Docket Number:	17-BSTD-02
Project Title:	2019 Title 24, Part 6, Building Energy Efficiency Standards Rulemaking
TN #:	222734
Document Title:	Bruce Severance Comments On 2019 Energy Code
Description:	N/A
Filer:	System
Organization:	Bruce Severance
Submitter Role:	Public
Submission Date:	2/26/2018 1:30:06 PM
Docketed Date:	2/26/2018

Comments on 2019 Energy Code

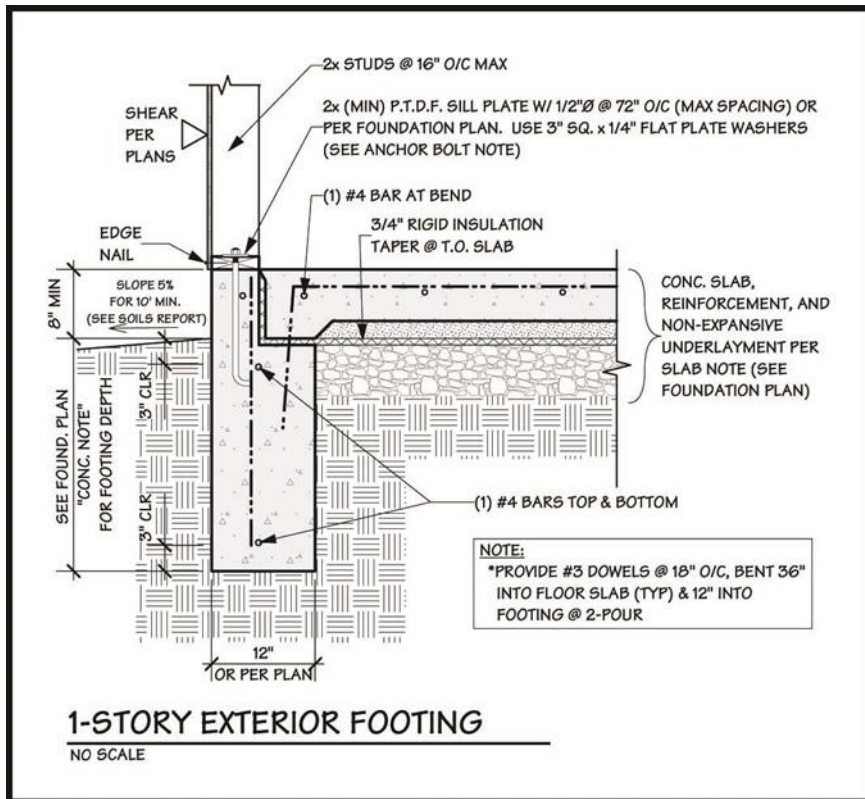
- 5) The slab insulation section drawings included in the 2016 Residential Compliance Manual are incorrect. The code requires sand between the horizontal foam and the poured slab to minimize cracking. Also, it is best to angle the top of the vertical foam that runs up the inside of the footing so that it is not exposed at the interior and does not result in damage to flooring materials when subjected to point loads caused by furniture that is often positioned against walls. (See detail below).
